This errata sheet provides updated information on known device issues affecting Cyclone® IV devices.

Table 1. Known Issues for Cyclone IV Devices (Part 1 of 2)

Figure 1. Programmable PPM Detector Options in the ALTGX MegaWizard Plug-In Manager

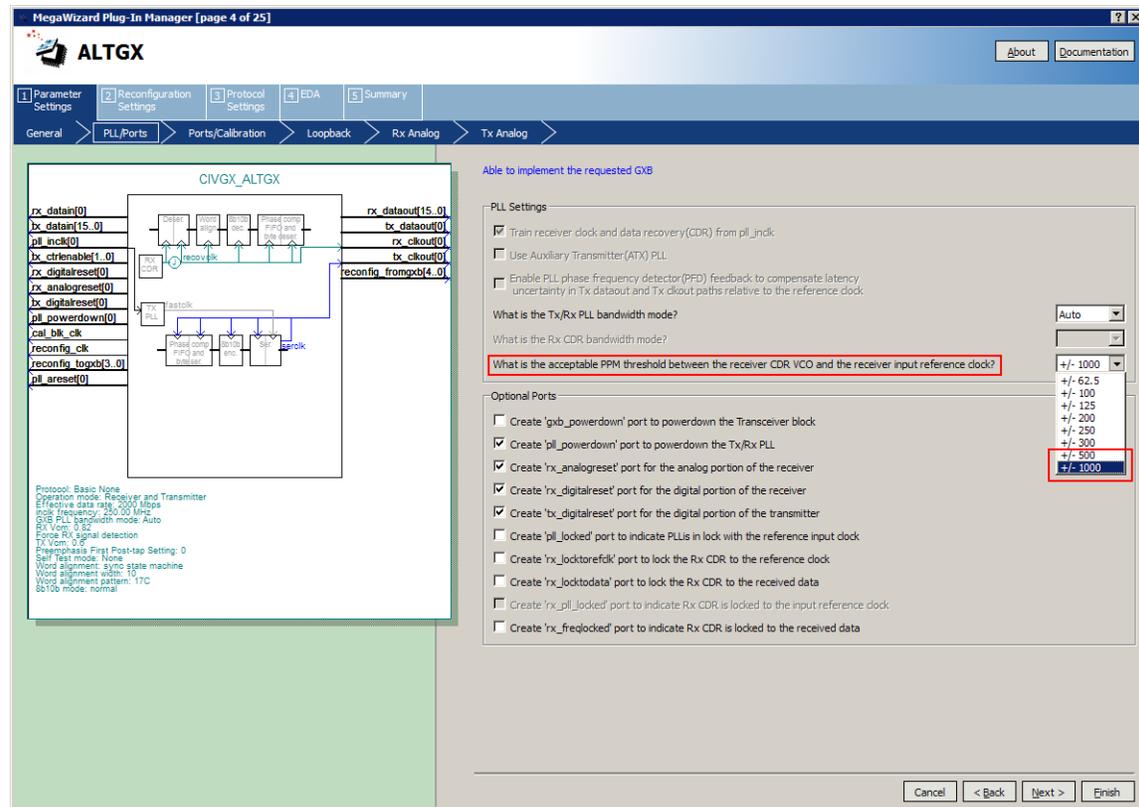
Removal of the ±500 PPM and ±1000 PPM Options for the Programmable PPM Detector in the ALTGX MegaWizard Plug-In Manager

The ±500 PPM and ±1000 PPM options for the Programmable PPM Detector feature in the ALTGX MegaWizard™ Plug-In Manager, as shown in [Figure 1](#), are no longer supported in the Quartus II software version 10.0 SP1 and later. These options are removed because the programmed PPM threshold values exceed the receiver CDR PPM tolerance between the upstream transmitter reference clock and the local receiver reference clock.

For a receiver design that has the ± 500 PPM or ± 1000 PPM options selected in the Programmable PPM Detector feature, Altera recommends evaluating the system operation with different options, ranging between ± 62.5 PPM and ± 300 PPM. To change the **Programmable PPM Detector** option, regenerate and recompile the ALTGX MegaWizard Plug-In Manager design file with the supported options.
